**SOLICITATION AMENDMENT
MODIFICATION DE L'INVITATION**

Title - Sujet Tactical Air Coordination Suite	
Solicitation No. - N° de l'invitation W8476-185751/C	Amendment No. - N° modif. 009
Client Reference No. - N° de référence du client 6000412936	Date 2020-12-18
GETS Reference No. - N° de référence de SEAG PW-\$\$QD-036-27880	
File No. - N° de dossier 036qd.W8476-185751	CCC No./N° CCC - FMS No./N° VME
Solicitation Closes - L'invitation prend fin at - à 02:00 PM Eastern Standard Time EST on - le 2021-01-15 Heure Normale de l'Est HNE	
F.O.B. - F.A.B. Specified Herein - Précisé dans les présentes	
Plant-Usine: <input type="checkbox"/> Destination: <input type="checkbox"/> Other-Autre: <input checked="" type="checkbox"/>	
Address Enquiries to: - Adresser toutes questions à: Briere-Provost, Mathieu	Buyer Id - Id de l'acheteur 036qd
Telephone No. - N° de téléphone (891) 790-1635 ()	FAX No. - N° de FAX () -
Destination - of Goods, Services, and Construction: Destination - des biens, services et construction:

This RFP Amendment 009 is raised to:

Figure 2 - RAPM Capability Demonstration

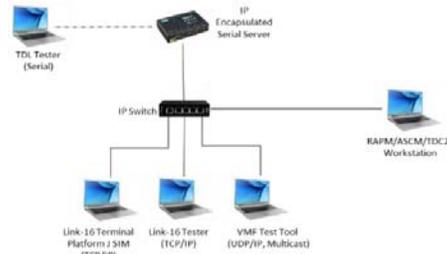
- 2.3. The Recognized Air Picture (RAP) Compilation and Airspace Coordination. The selected RAP Management (RAPM) and ASCM requirements that fit in the context must be

demonstrated. The selected TDC2I requirements that support the RAPM and ASCM capabilities must also demonstrated.

The systems configuration presented in the Figure 2 - RAPM Capability Demonstration is served as a reference only and should not be considered as the demonstration requirement.

Figure 3 - Full Capability Demonstration

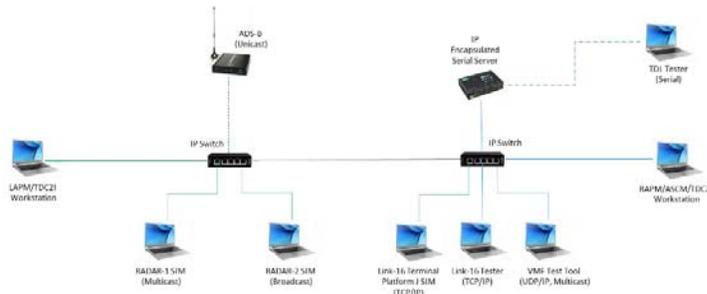
- 2.4. The Full Capability. All selected requirements that fit in the context must be demonstrated in an interactive fashion.

The systems configuration presented in the Figure 3 - Full Capability Demonstration is served as a reference only and should not be considered as the demonstration requirement.
